Port of Ashburton – Port Entry Light (PEL) relocation and realignment – ACW Approach Channel

Number: A24/2026 **Date: 9/11/2026**

Figure 1

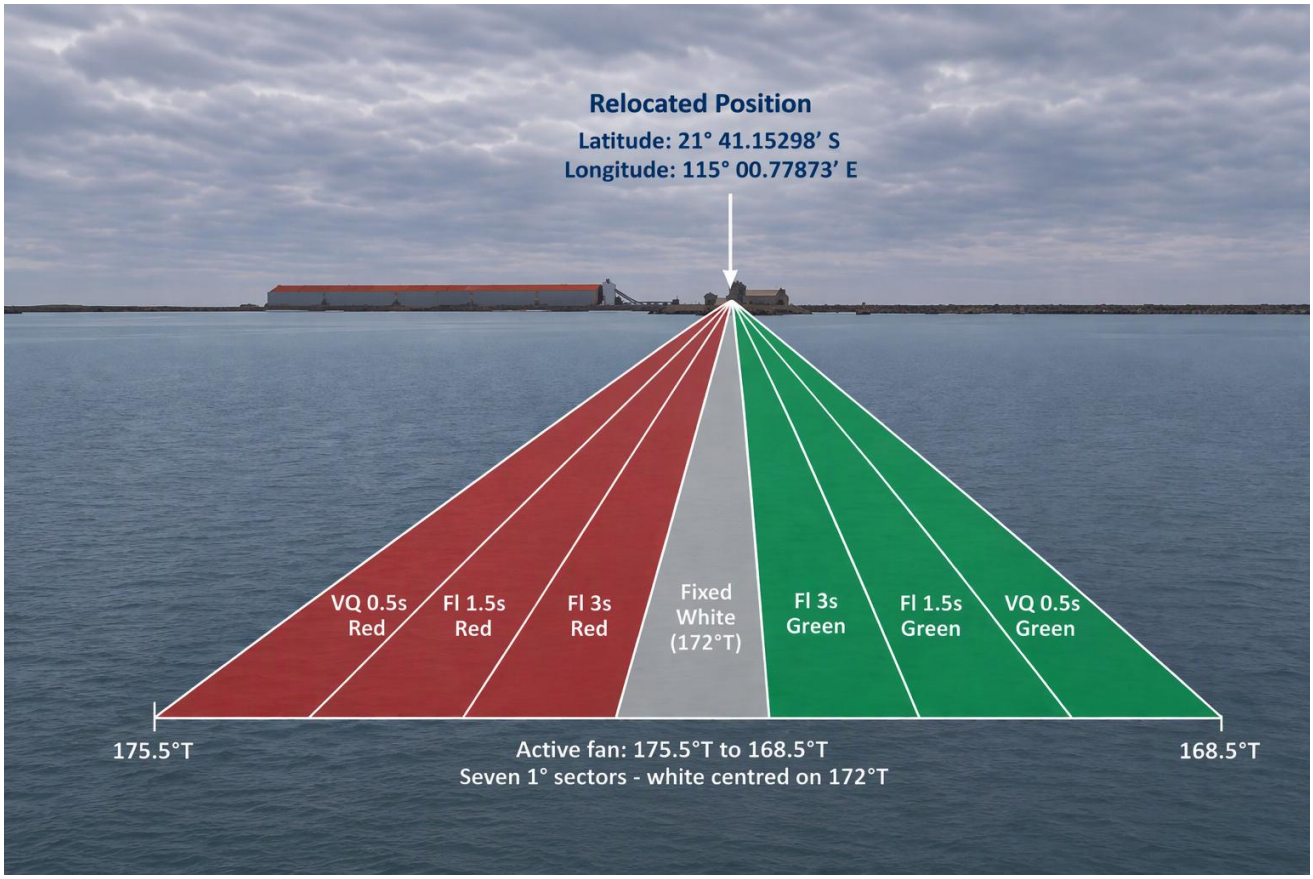
This Local Marine Notice supersedes A22/2026 and provides updated information on the relocation and realignment of the Port Entry Light (PEL) serving the Ashburton Cargo Wharf (ACW) approach channel, which provides visual guidance for vessels navigating the ACW approach channel and the Mineral Resources Limited Terminal approach. Updated PEL information is provided in Table 1.

Item	Description
Aid to navigation	Port Entry Light (PEL)
Position (Datum: GDA2020)	21° 41.15289' S & 115° 00.77873' E
Centreline bearing	172° T
Sector light characteristics	Refer to Figure 1
Operational range (in nautical miles NM)	2 NM (day) / 12 NM (night)
Operational period	Day and Night
